12 SUB2009-00022

LANGHAM FAMILY DIVISION SUBDIVISION, RESUBDIVISION OF LOTS 1 & 2

LANGHAM FAMILY DIVISION SUBDIVISION, RESUBDIVISION OF LOTS 1 & 2

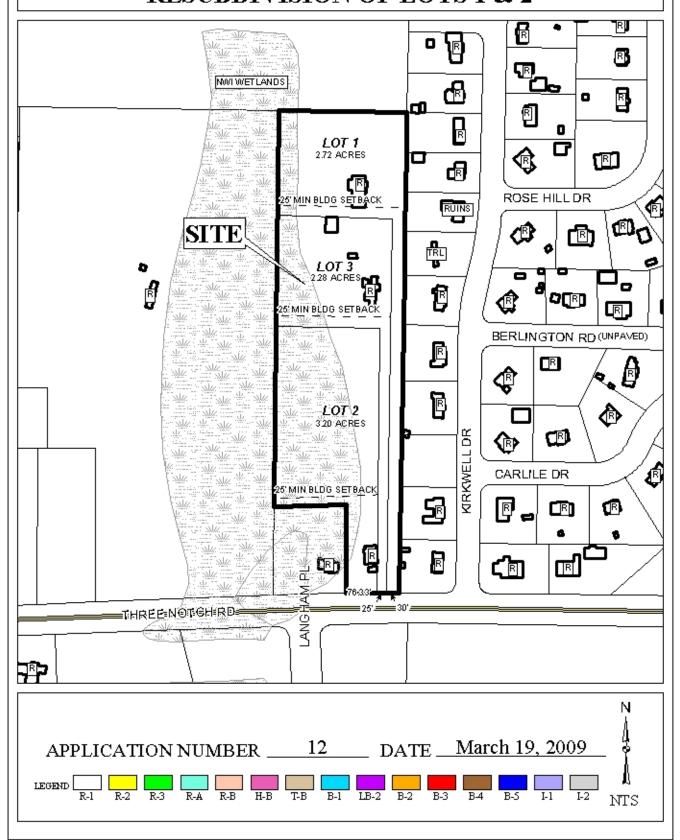
The site fronts Three Notch Road, a major street with 80' of right-of-way. The Major Street Plan requires that Three Notch Road have a minimum 100' of right-of-way. Thus, the applicant should revise the plat to dedicate sufficient right-of-way so as to provide a minimum 50' from the centerline of Three Notch Road.

As proposed, Lots 1, 2, and 3 have approximately 30', 76', and 25' of frontage along Three Notch Road respectively. As a means of access management, a note should be placed on the final plat stating that each lot is limited to one curb cut to Three Notch Road, with the size, location, and design to be approved by County Engineering and in conformance to AASHTO standards.

The title on the preliminary plat indicates that the applicant is re-subdividing Lots 2 and 3 of Langham Family Division. Actually, however, it is Lots 1 and 2 of Langham Family Division that are being re-subdivided. The applicant should revise the plat accordingly.

- 1) dedication of sufficient right-of-way so as to provide a minimum 50' from the centerline of Three Notch Road;
- 2) placement of a note stating that each lot is limited to one curb cut to Three Notch Road, with the size, location, and design to be approved by County Engineering and conform to AASHTO standards;

- 4) the applicant correct the title of the subdivision (should be *Langham Family Division*, *Resubdivision of Lots 1 and 2*);
- 5) the applicant receive the approval of all applicable federal, state and local environmental agencies prior to the issuance of any permits or land disturbance activities;
